NUMBER 91

SUBJECT: Inspection of Fuel Strainer Installation

MODELS AFFECTED: Piper J3C-65 Airplanes  
Serial Nos. 14027 through 17959

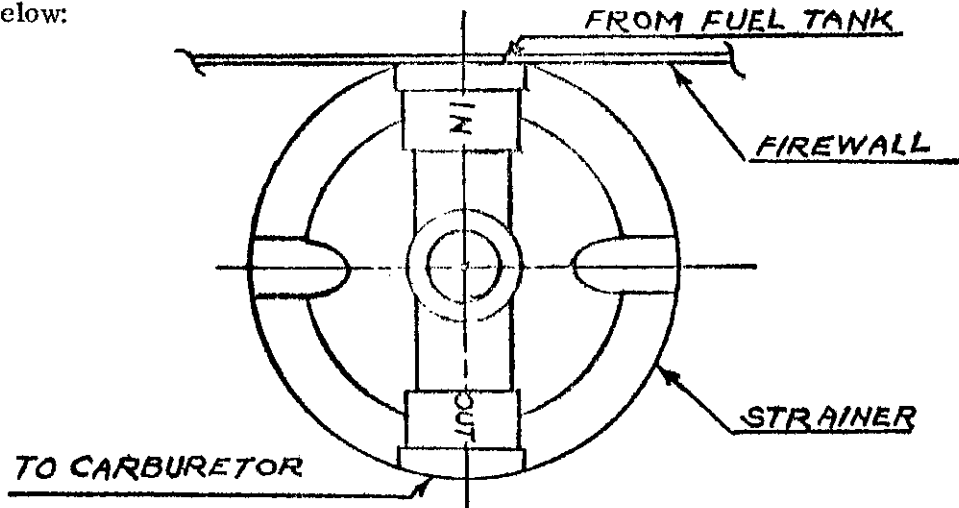
It has been brought to our attention that several J3C-65 airplanes have left the factory with the fuel strainer ports inadvertently reversed. Therefore, we are requesting that all owners inspect their airplanes for proper installation.

The ports are identified by the words "IN" and "OUT" in raised letters on the strainer cover. The proper installation and location of ports is shown below:

If the fuel strainer is not installed as indicated above, it should be reversed for proper fuel flow.

An appropriate entry should be made in the aircraft log book at the time this inspection is made.
